Re: BusConnects Swords to City Centre Bus Corridor Scheme
Swords to Dublin City Centre

ABP case ref: 317121

BUSCONNECTS SWORDS CORE BUS CORRIDOR SCHEME

Figure 9 Improperly segregated junctions on Dorset Street

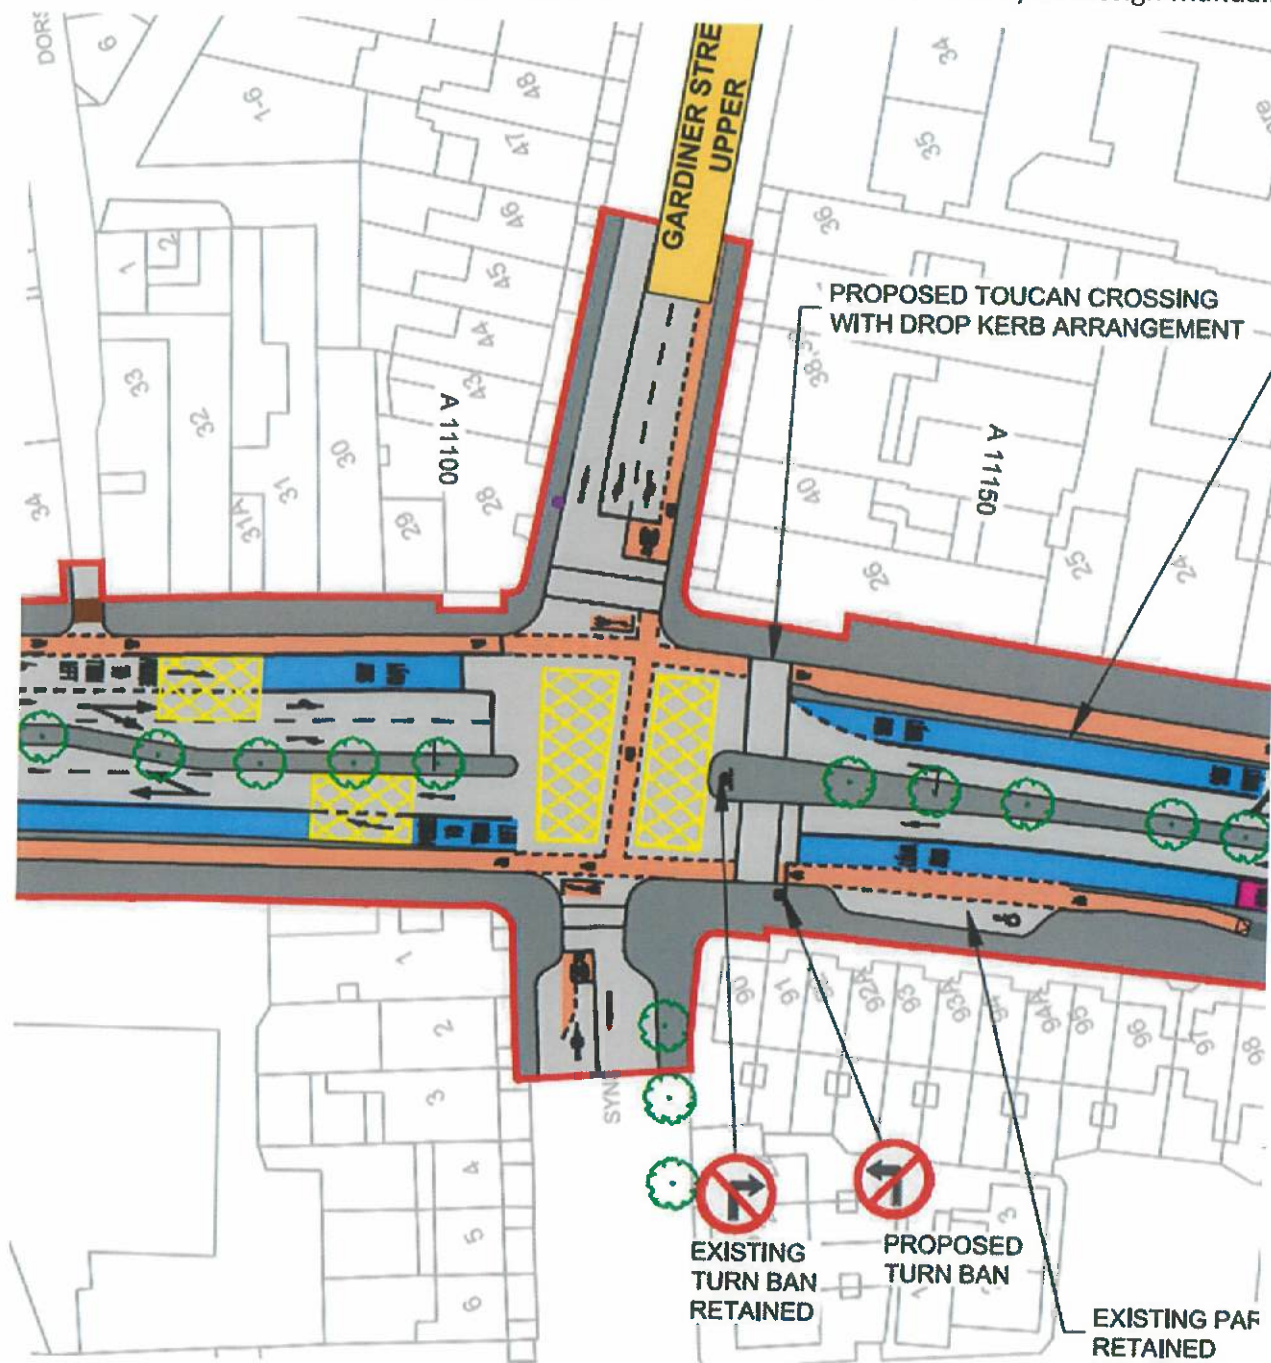
The unsegregated and poorly segregated junctions on Dorset Street are not safe and suitable for all ages and abilities. We ask that these junctions be replaced with fully segregated Dutch junctions Protected T-Junction TL504 and Protected Junction TL501 of the Cycle Design Manual.
